Product Change Notice

PCN#: EE-PCN24015

Outer sleeve printing design change on both TV and TVA series. Affected PNs are included in below table.

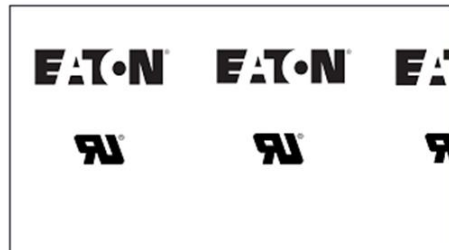
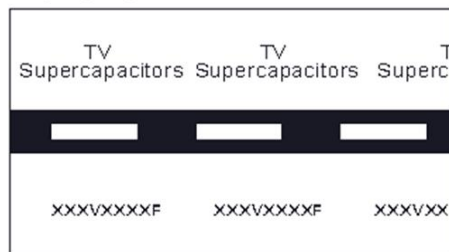
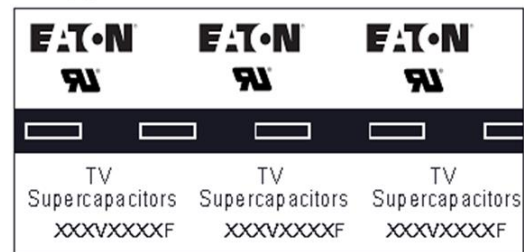
Move all text printing to be same half side of top view with polarity line. Same change is applied to both TV and TVA series but just different series name only.
